**KNOXVILLE/KNOX COUNTY METROPOLITAN PLANNING COMMISSION
USE ON REVIEW REPORT**

▶ **FILE #:** 2-D-08-UR

▶ **PROPOSED USE:** Residential condominiums

▶ **APPROVE the development plan for up to 30 residential condominium units in the PR (Planned Residential) zoning district, subject to the following 10 conditions:**

DESIGN PLAN FOR:
COPPERLEAF CONDOMINIUM AT
HESKELL RD.
DISTRICT 6, ANOKA COUNTY, TENNESSEE

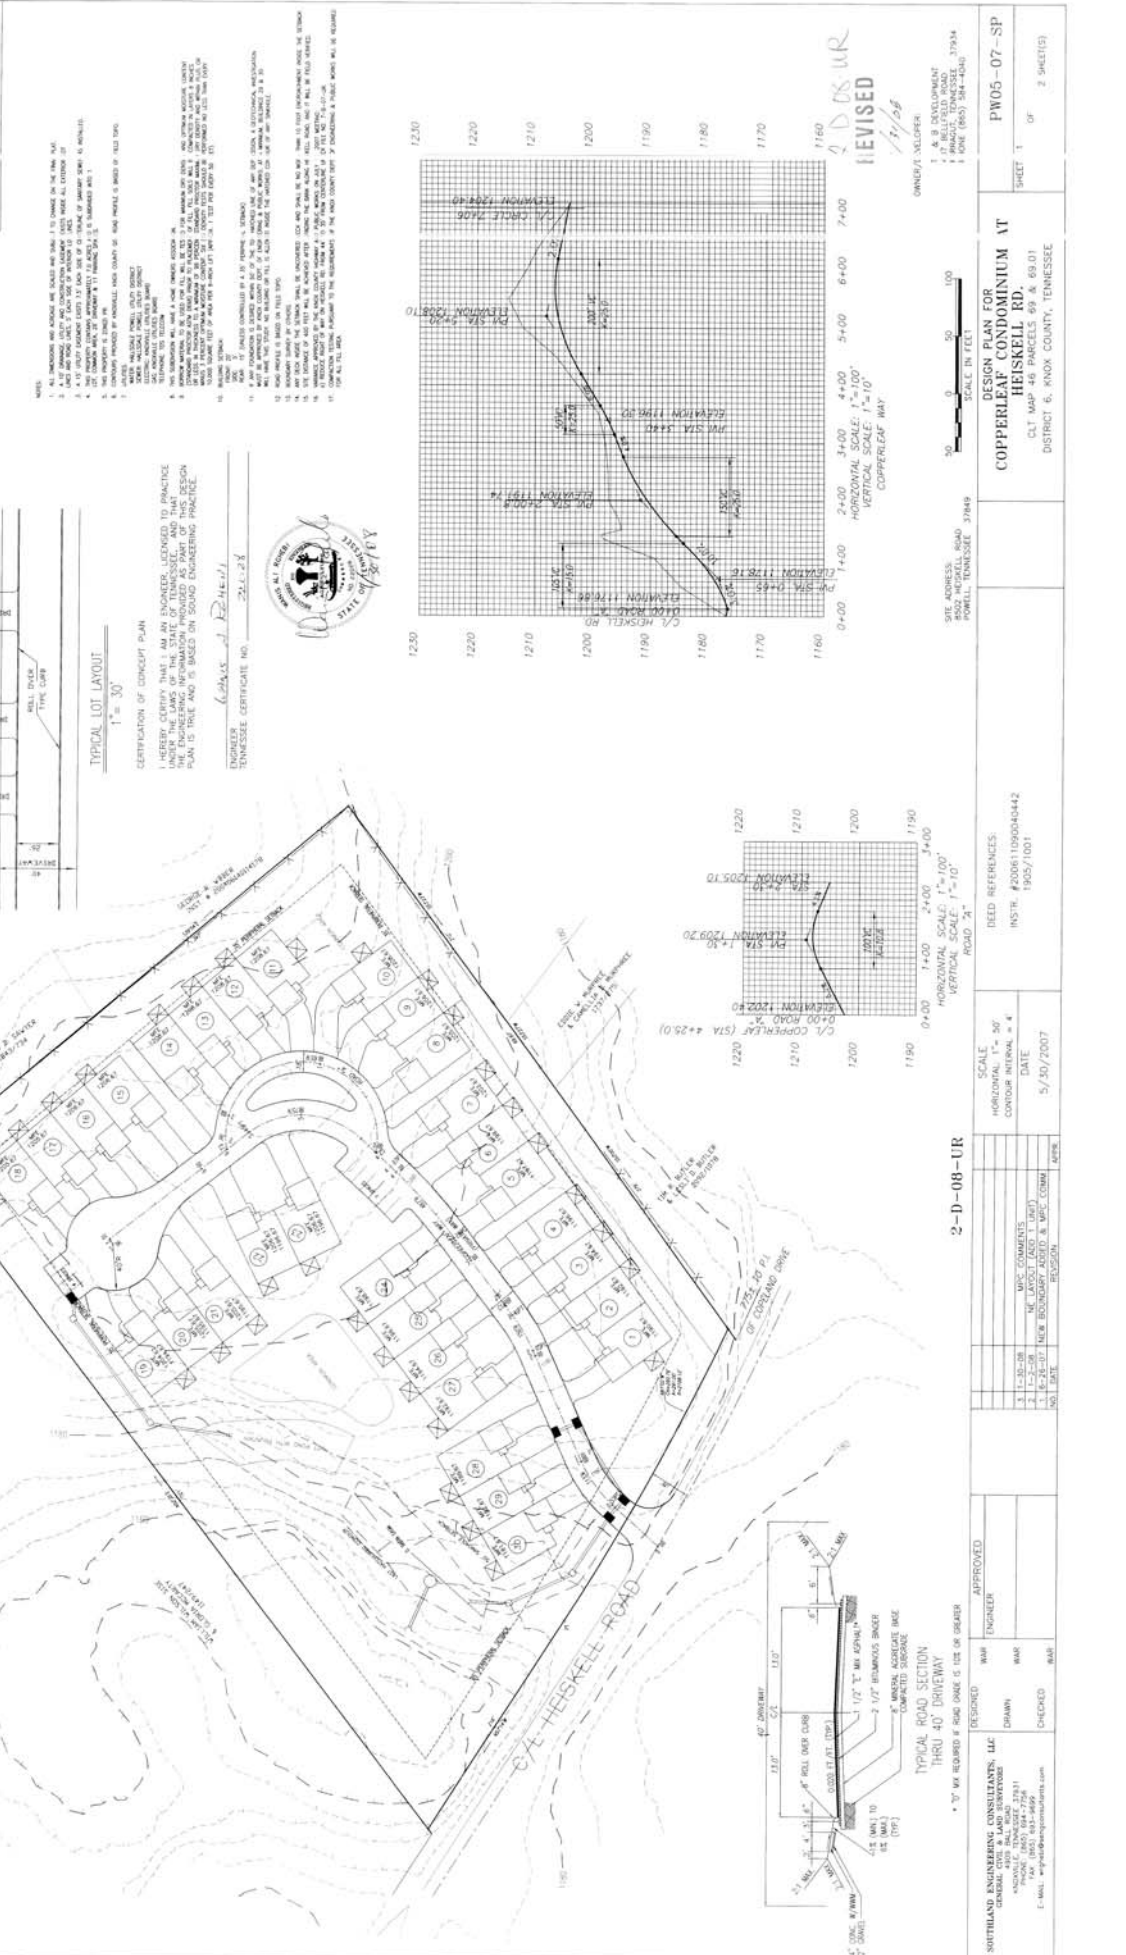
7. As part of the grading plan, certification by the applicant's surveyor that there is the required 400' of sight distance in both directions along Heiskell Rd. at the development's entrance. The bank along Heiskell Rd. may need to be graded in order to achieve adequate sight distance and field verified by Knox County Engineering and Public Works prior to the issuance of a building permit.
8. Place a note on the development plan that all units will have access only to the internal street system.
9. No structure shall be placed within 50' of the last closed contour of the on-site sinkhole.
10. Recording a plat that combines parcels 69 and 69.01.

The applicant is requesting approval of a 30 unit condominium development. The development will access Heiskell Road and have a private interior roadway. A previous use-on-review was approved for 29 units in July of 2007 (7-B-07-UR). There is a significant sinkhole located in the southeast corner of the property. The applicant will not be allowed to build within 50' of the last closed contour of that sinkhole.

Upon field review, sight distance appeared to be an issue. The applicant may be required to grade the bank along Heiskell Rd., near the proposed entrance in order to obtain adequate sight distance. This grading will have to be field verified by the Knox County Department of Engineering and Public Works prior to the issuance of a building permit.
